Road Safety Audit Report

Proposed Extension of Wychwood Green Crawley Down

Technical Note: RSA GG119 Response – Wychwood Place Extension

Technical Note: RSA GG119 Response – Wychwood Place Intensification

TITLE: PROPOSED ACCESS ROAD EXTENSION

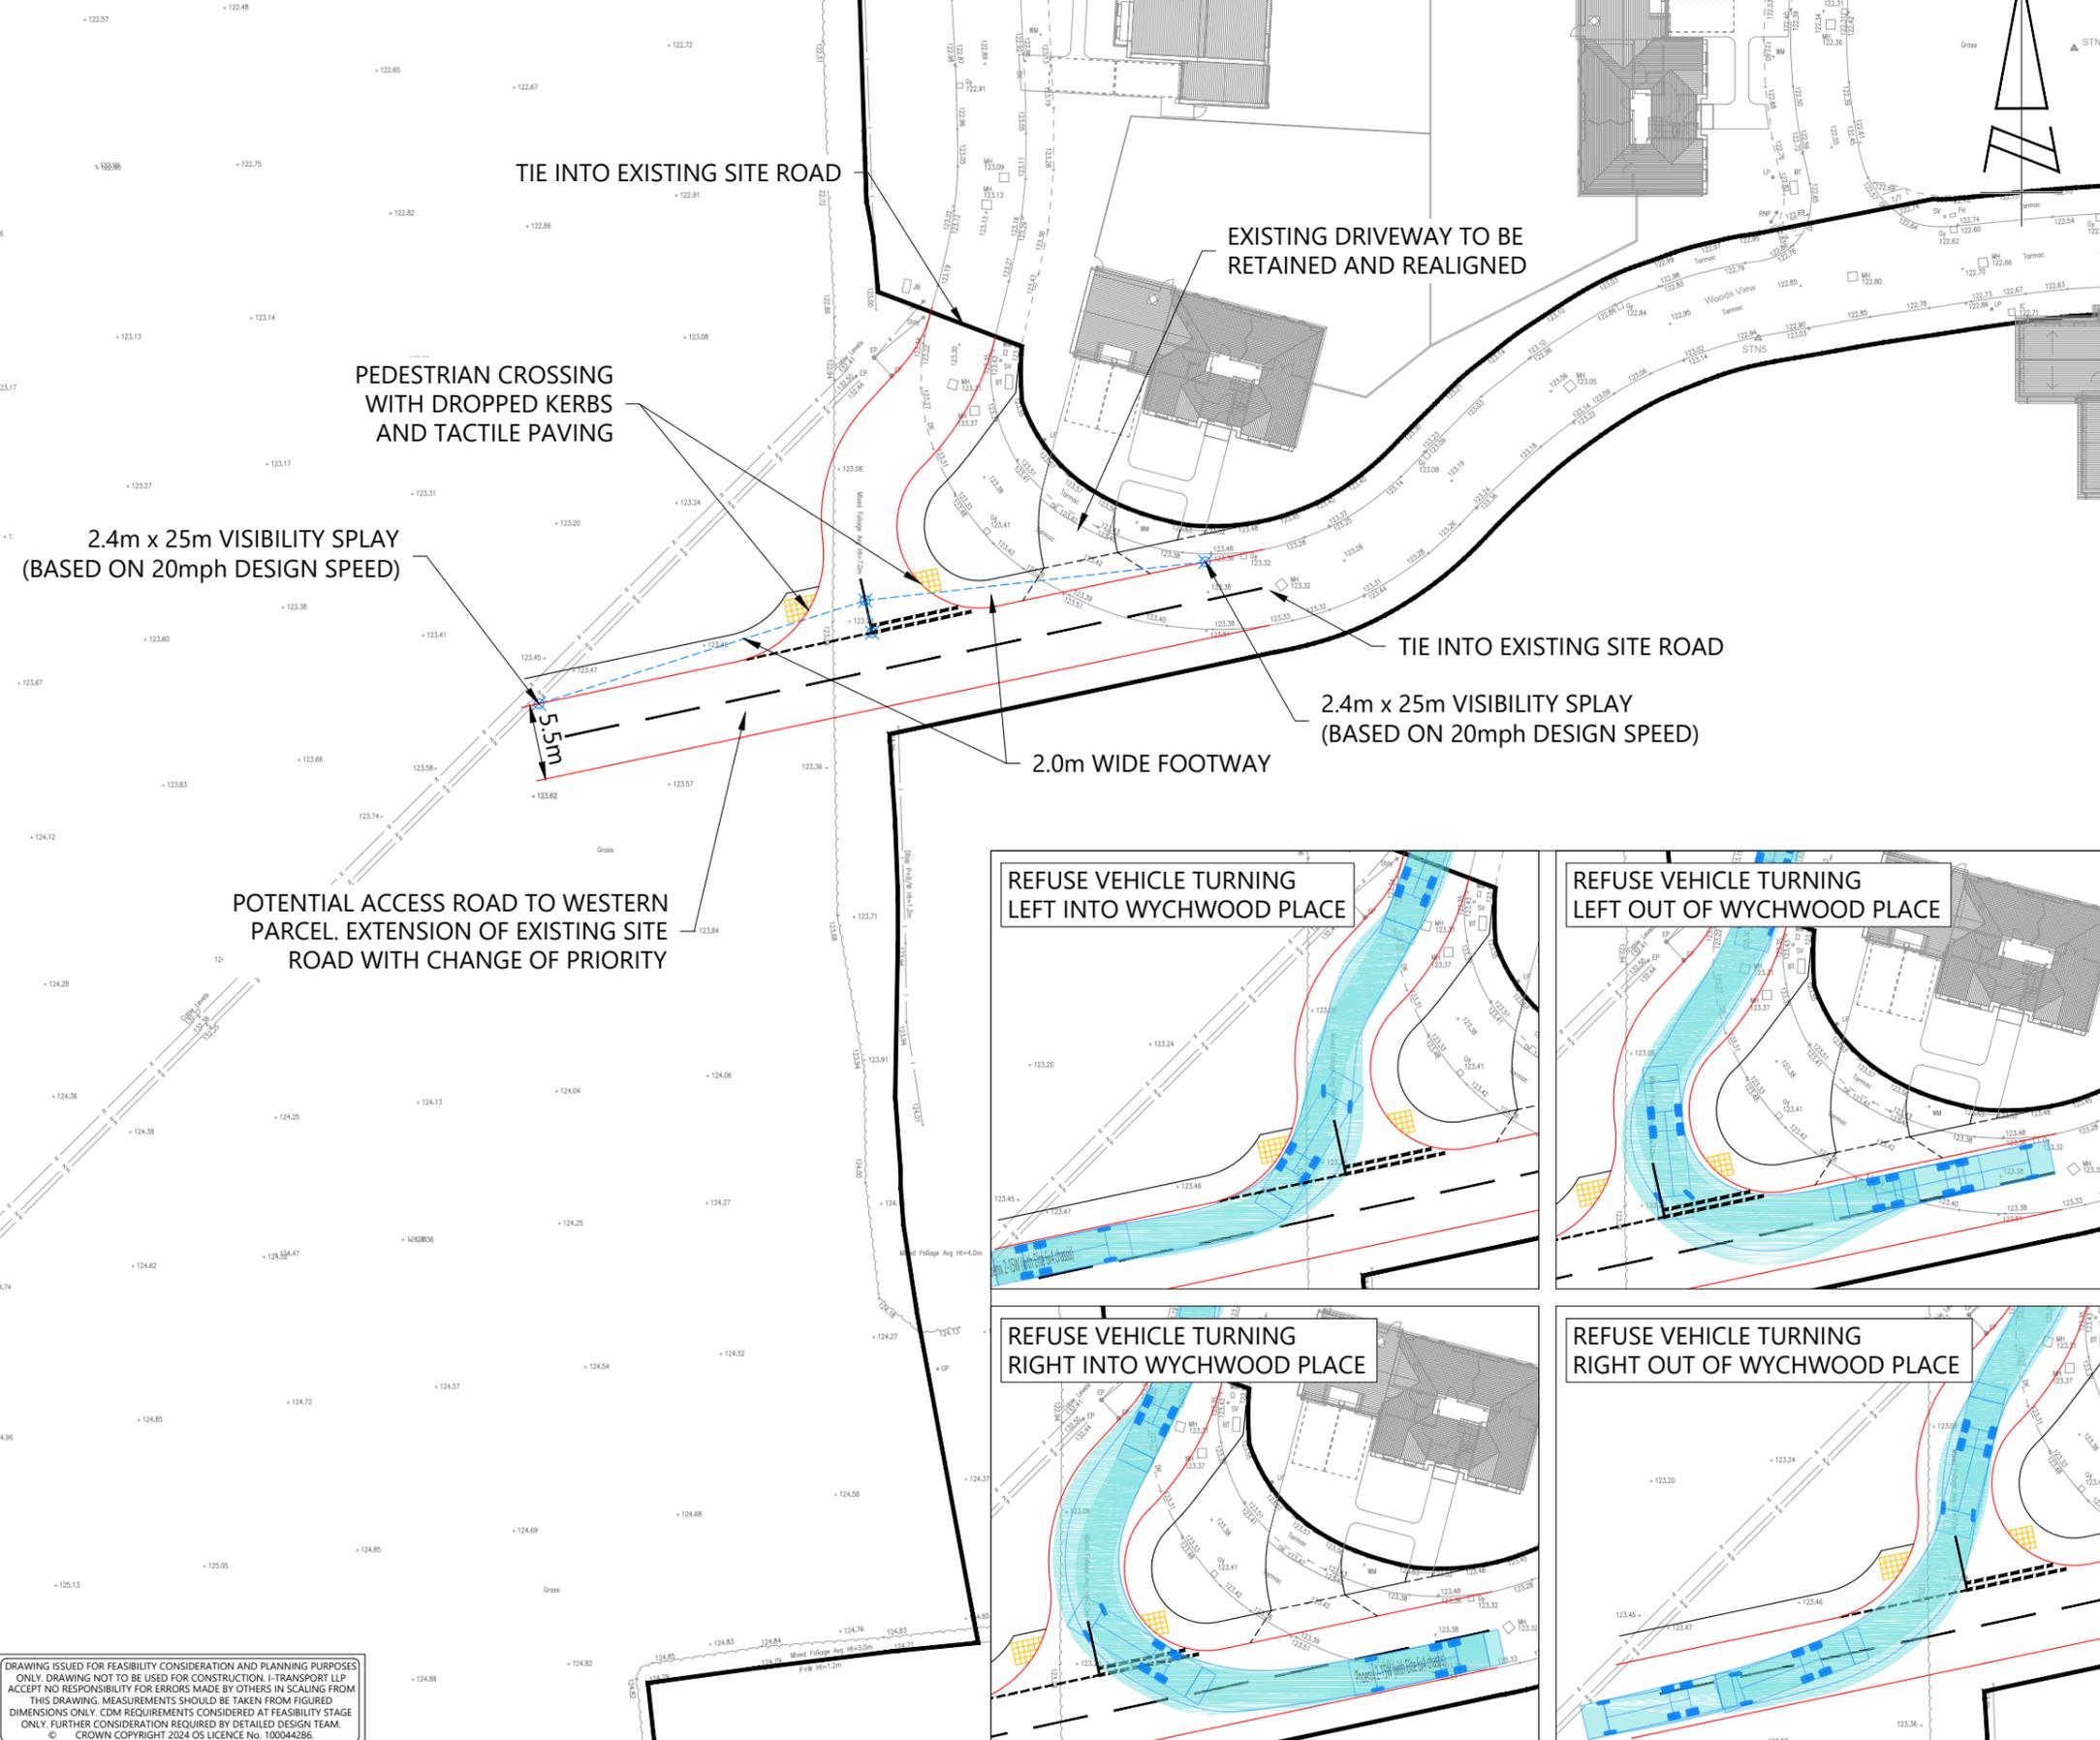
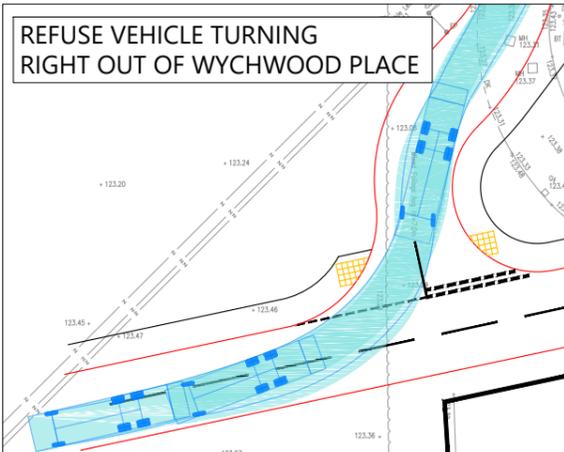
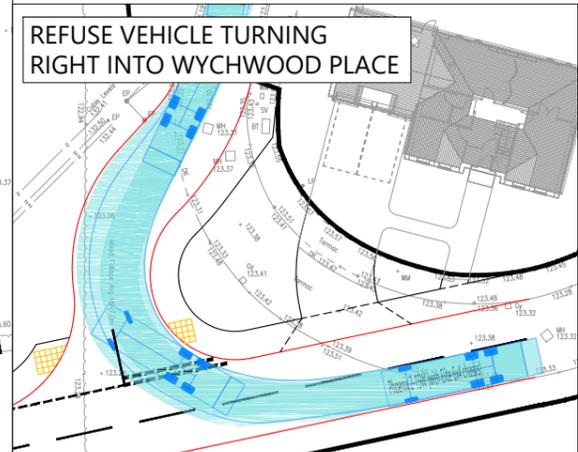
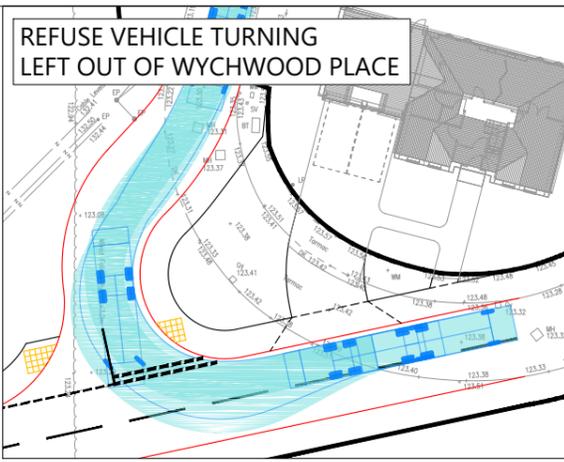
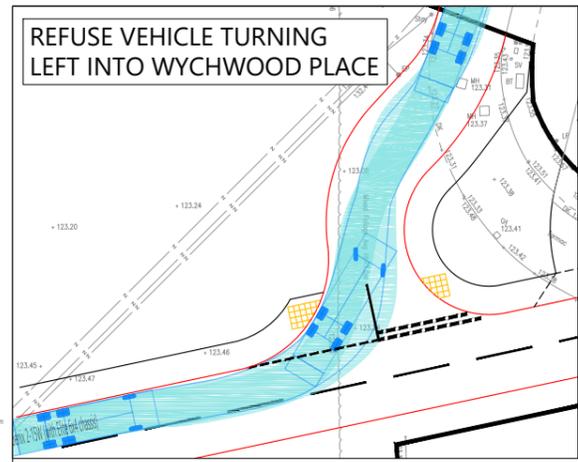
A.1	LOCAL ALIGNMENT
	<i>No Road Safety Concerns regarding LOCAL ALIGNMENT have been raised at this stage.</i>
A.2	GENERAL
A.2.1	PROBLEM
Location:	Woods View
Summary:	Realigned carriageway may not allow for the large vehicles
Acc Type:	Sideswipe type collisions
<p>The 5.5 metre wide Wychwood Place continues as Wychwood Green before continuing as Woods View following a bend in the road before the carriageway narrows to 5.0 metres. The proposals include an extension of the 5.5 metre section of Wychwood Green which is to continue into the application site. The section of Woods View that currently follows a bend in the road is to be marginally realigned and widened to 5.5 metres around a circa 9 metre road centreline radius on approach to a simple priority junction with the extension. Whilst the extension of the 5.5 metre carriageway should be adequate to accommodate the expected vehicles, the Audit Team have concerns that the realigned Woods View will not allow for large vehicles to include refuse / recycling collection vehicles. A carriageway that is inadequate for the expected vehicles, could result in the need for a large vehicle to encroach the adjacent footway / verge and could lead to loss of control or sideswipe type collisions.</p>

RSA Problem	RSA Recommendation	Design Organisation Response	Overseeing Organisation Response	Agreed RSA Action
<p>A.2.1 The 5.5 metre wide Wychwood Place continues as Wychwood Green before continuing as Woods View and following a bend in the road where the carriageway narrows to 5.0 metres. The proposals include an extension of the 5.5 metre section of Wychwood Green which is to continue into the application site. The section of Woods View that currently follows a bend in the road is to be marginally realigned and widened to 5.5 metres around a circa 9 metre road centreline radius on approach to a simple priority junction with the extension. Whilst the extension of the 5.5 metre carriageway should be adequate to accommodate the expected vehicles, the Audit Team have concerns that the realigned Woods View will not allow for the vehicles that can be expected to include refuse / recycling collection vehicles. A carriageway that is inadequate for the expected vehicles, could result in the need for a large vehicle to encroach the adjacent footway / verge and could lead to loss of control or sideswipe type collisions.</p>	<p>It is recommended that the realigned carriageway allows for the expected vehicles.</p>	<p>Agreed. Minor widening has been undertaken. Vehicle tracking for a refuse collection vehicle has been undertaken and shown as an inset in drawing ITB9155-GA-048C and demonstrates that there is adequate space along the realigned carriageway for the expected vehicles. Such vehicles will be occasional and are expected to be the largest vehicle that would make the manoeuvre.</p>

REV	DATE	BY	DESCRIPTION	CHK	APD
C	16.01.25	MM	SITE BOUNDARY UPDATED	DG	MS
B	29.11.24	SH	RSA COMMENTS INCORPORATED	MS	MS
A	21.10.24	MM	SITE BOUNDARY UPDATED	MS	MS
